SITE SERVICING STUDY & STORMWATER MANAGEMENT REPORT

**1386-1394 GREELY LANE
OTTAWA, ONTARIO**

REPORT No. 24015

**JANUARY 13, 2025
REVISED MARCH 6, 2025
REVISED MARCH 24, 2025
REVISED JULY 30, 2025
REVISED SEPTEMBER 29, 2025
REVISED NOVEMBER 20, 2025**

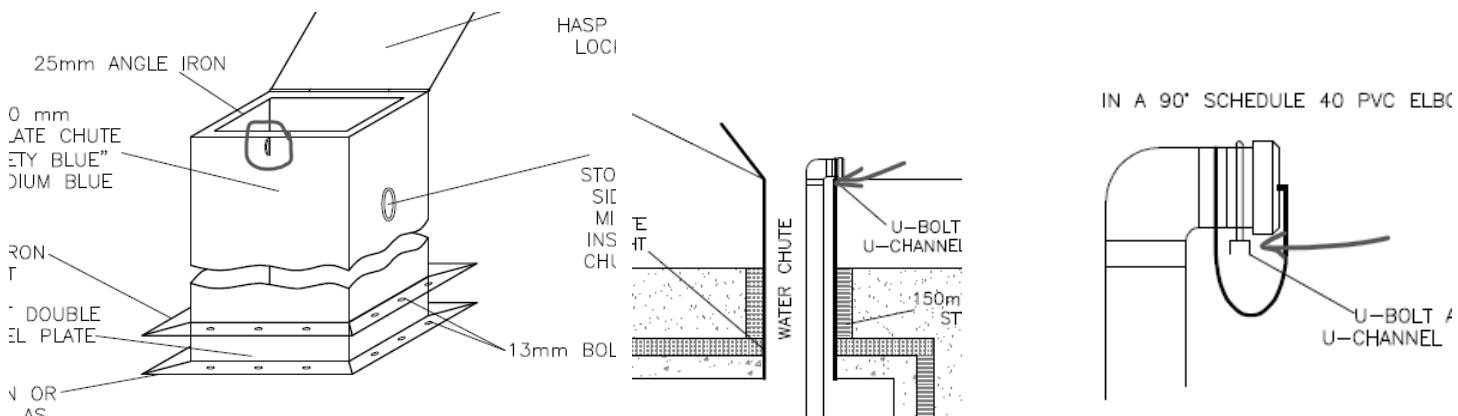
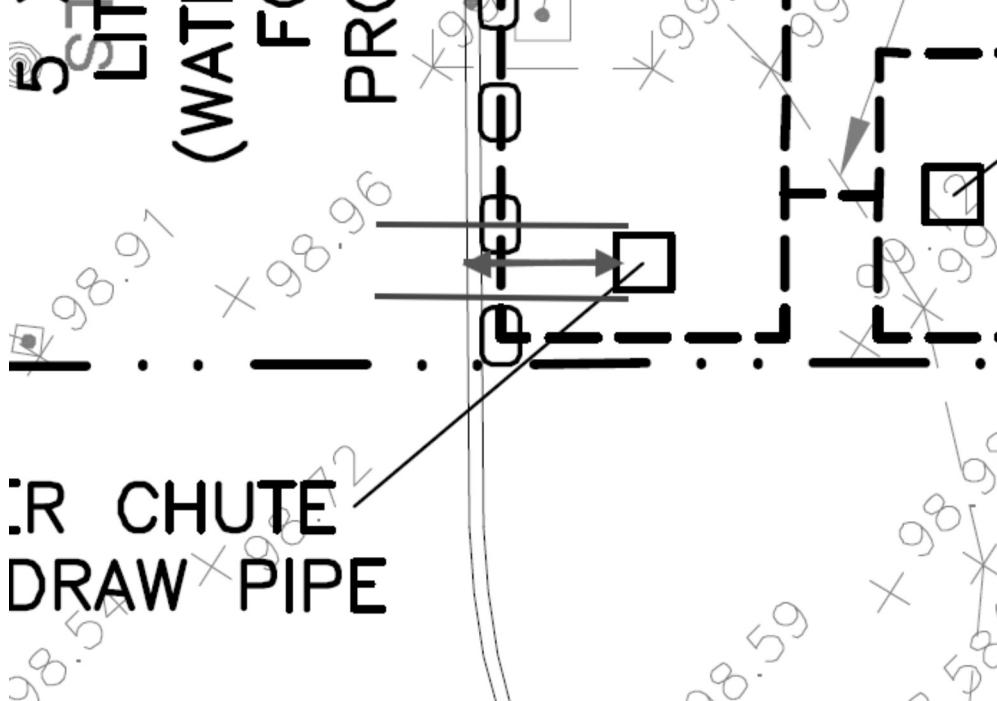
Apologies, I don't mean to keep adding observations with each change, but I also don't want there to be misunderstandings that will get missed and become bigger problems later on.

I assume the chute on the other tanks are just for access (and/or vent)? Correct. To be clearer the access opening are now labelled: "ACCESS OPENINGS WITH VENTS (NO DRAW PIPES)" and the water chute is labelled as "WATER CHUTE WITH DRAW PIPE". They aren't required to be chutes, but I leave it up to you to decide – just be sure these non-fire use ones are NOT painted blue – blue is an indicator of "draft" for Ottawa Fire Services so only the one we are drafting from with a chute should be blue. Our details on drawing C-8 have been revised. The 'Water Fill Station' detail now has the following note: "ONLY ONE TANK SHALL HAVE A DRAW PIPE (AS INDICATED ON PLANS). TANKS WITHOUT A DRAW PIPE SHALL HAVE AN ACCESS OPENING WITH A 150 mm "CANDY CANE" VENT C/W WITH RODENT SCREEN. THE ACCESS OPENINGS SHALL NOT BE PAINTED BLUE." Also worth noting that depending on the size of the interconnecting pipes between tanks, an anti-vortex plate may be required – I'll leave it to your engineering judgement on these. The interconnecting pipes are 250mm in diameter. At 4500 L/min the velocity is only 1.5 m/s so an anti-vortex plates should not be required. I would be more concerned with the 150mm draw pipe, which at 4500 L/min, the velocity is 4.2 m/s. The bottom of the draw pipe used to be cut on an angle but, especially now that the bottom is 'cut square', I would expect that vortexing could be an issue. Have you experienced vortexing with a 'cut square' draw pipe?

I also wanted to draw the attention to something I've mentioned in meetings past (I think with you, but possibly not). Be sure that the padlock hole doesn't interfere with the u-channel on the draft pipe since it rests on the ledge of the box. Typically this is done by extending the hasp and lowering the eye for the lock. The following note is now on our 'Water Chute' detail: "THE STAPLE SHALL NOT INTERFERE WITH THE U-CHANNEL ON THE DRAW PIPE."

I noticed there isn't a specification for the distance from the curb to the closest edge of the draft chute (bottom picture red arrow line). This dimension is important since we are using a fixed length of hard suction (3m) to connect. The connection port on the fire truck is often slightly inset of the outer edge of the truck (i.e. further away) so the distance curb to close-edge of chute should be in the 1.5-1.8m distance (we can tolerate up to about 2m). We have added a dimension on drawing C-1 ($\pm 1.6m$ MAX. 1.8m). We have also added the following note on the 'Water Fill Station' detail: "THE FRONT FACE OF WATER CHUTE SHALL BE LOCATED A MAXIMUM 1.8m FROM FIRE ROUTE". On the 'Water Fill Station' detail we specify 'Boyd Bros Concrete or Approved equal' because they make a 45,000 L tank that is about 2.7m wide. Other tanks are 3.05m (10 ft) which may make it difficult to achieve the maximum 1.8 m (or up to 2.0 m) and keep the tank at least 0.5m from the edge of the asphalt.

And finally on a related note I see that you are using armour stone to also help protect the draw chute. In general that's fine, but please be sure that the height of the armour stone will not interfere with the suction hose (it is very inflexible). It may be advisable to leave a gap between the stones directly in front of the draft box at least the width of the box wide (blue lines). The following note has been added to C-1: "THERE SHALL BE NO ARMOUR STONES DIRECTLY IN FRONT OF WATER CHUTE".

Revised drawings C-1 & C-8 are attached. Please refer to my comments in red below.

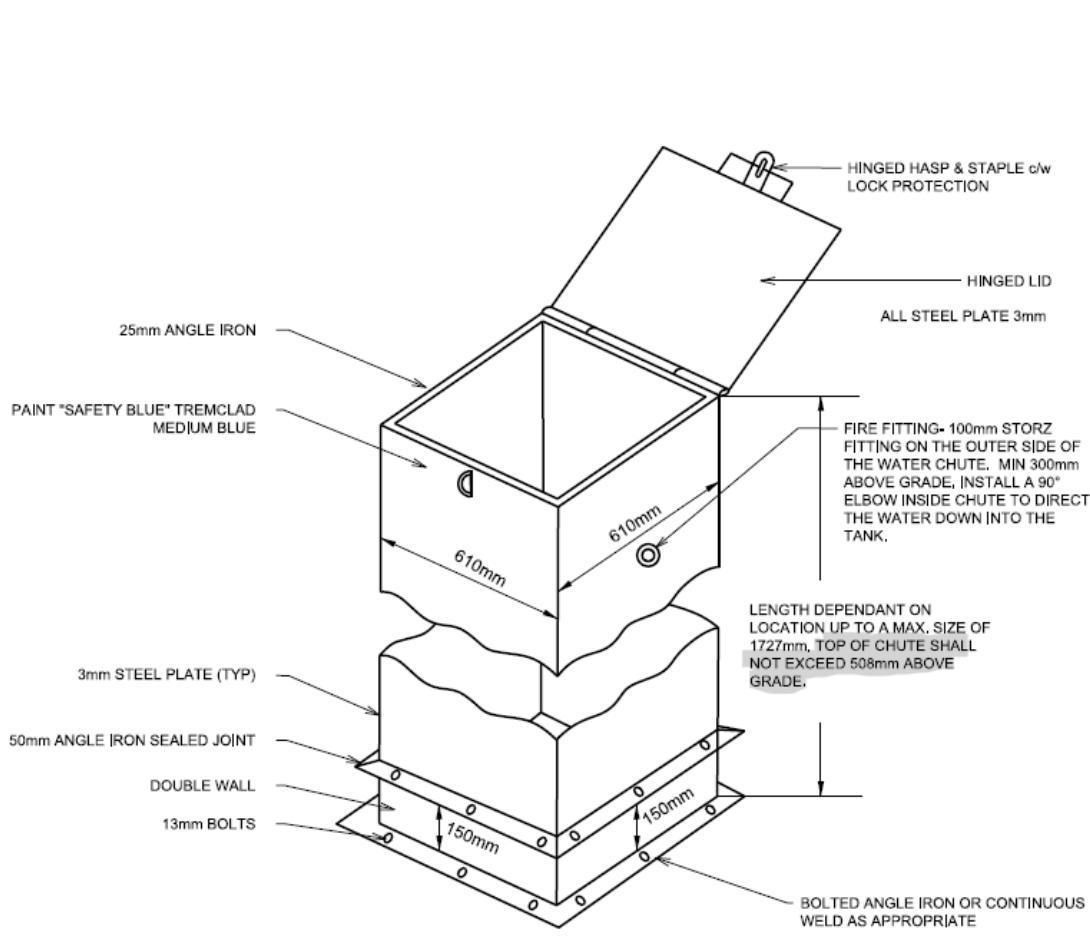
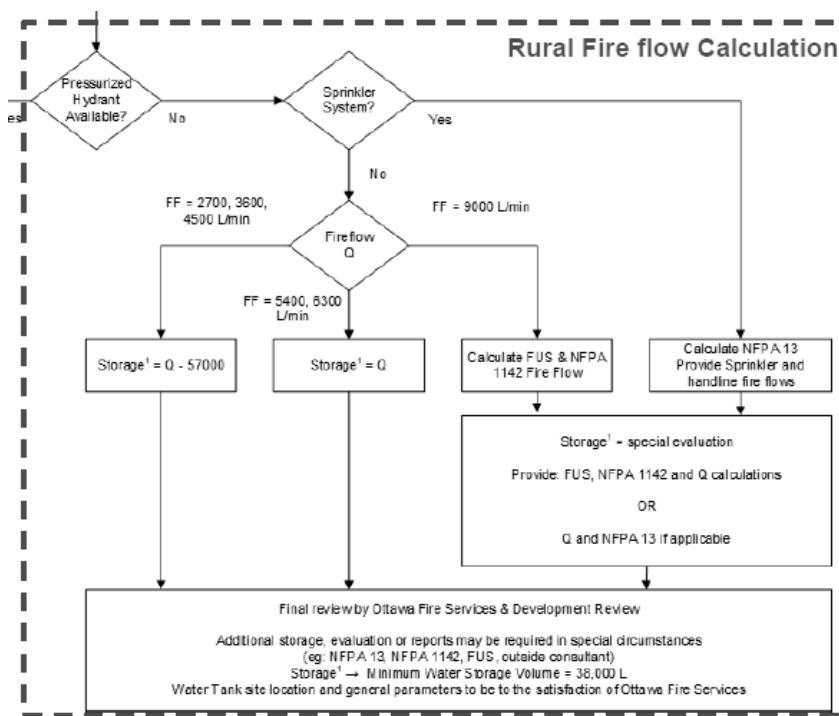
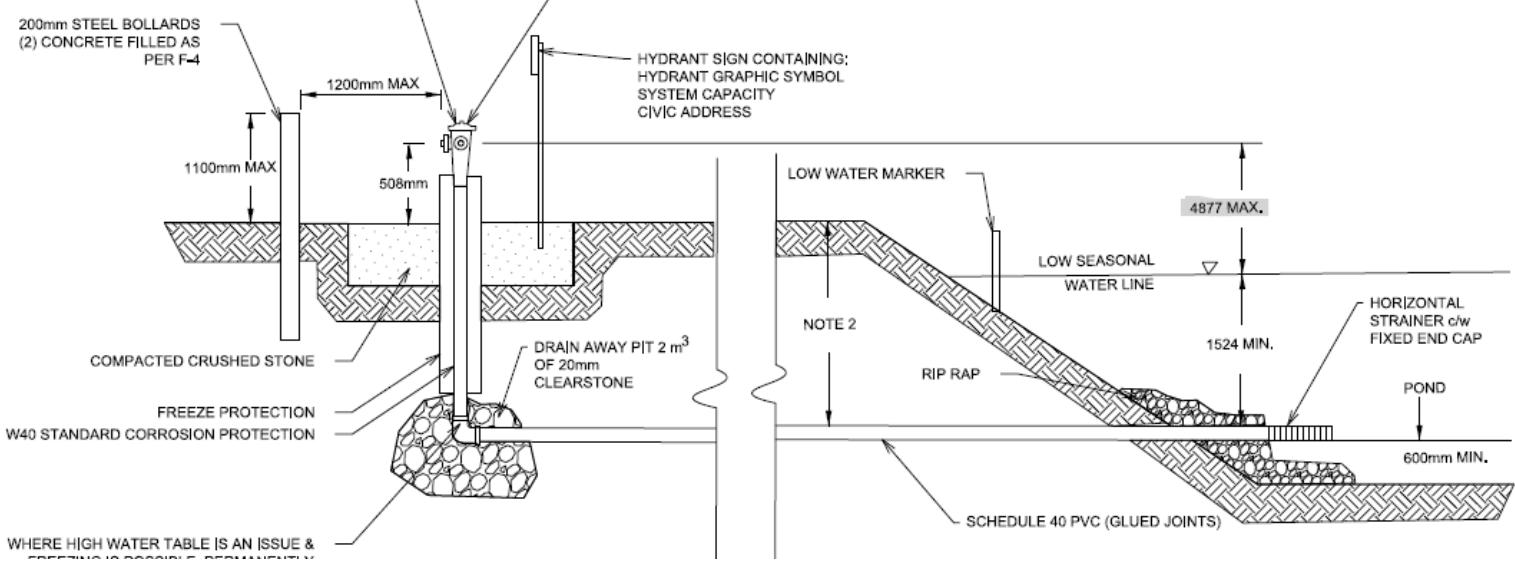
Qbuild = 225 000 L (ensure these tanks are 45000 L and not a 10000 US Gal (37 850 L))

Since FF > 4500 L/min, no reduction in Q is permitted

Qbuild > Qcalc -> therefore acceptable

Damien reminded me that the W51 spec has some specs that are out of date (my best guess is they were specified back when there were limited tanks available).

The specifications I wanted to highlight are:

- maximum draft height (lip of chute to bottom of tank) 4877mm (16 feet) (I used the value from the pond/river draft (bottom drawing))
- Top of chute above grade should be between 610 mm (24") – 813 mm (32") (**disregard** the 508mm maximum in drawing)

- there is some minor flexibility on the upper number but I wanted to provide a target range. The goal is to make sure it is not easily covered in winter (not too low), safe (too low leads to risk of falling in) and comfortable to lift the pipe inside out (not too high)
